Park Hill School District

Request for Proposal: Videoboard System for High School Competition Gym

Addendum 1:

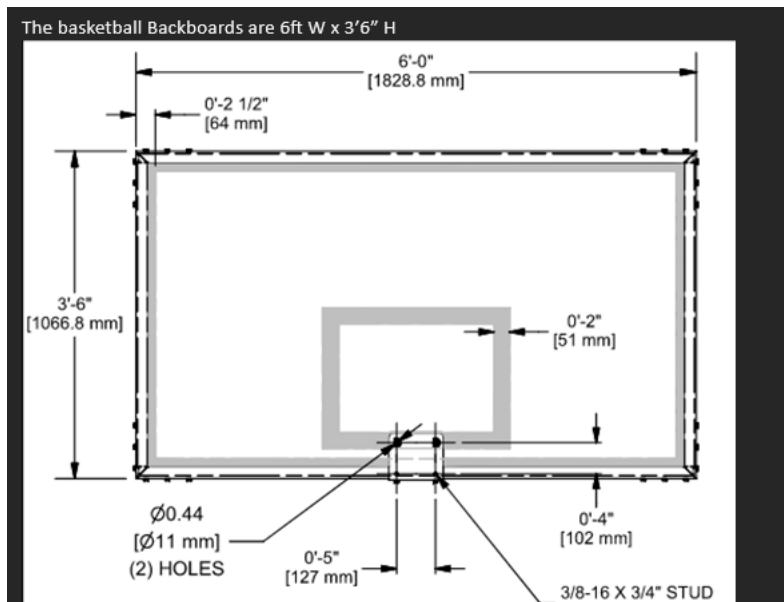
Q8. Can you supply drawings on the gyms for install pricing?

A8. Yes, please see documents below.
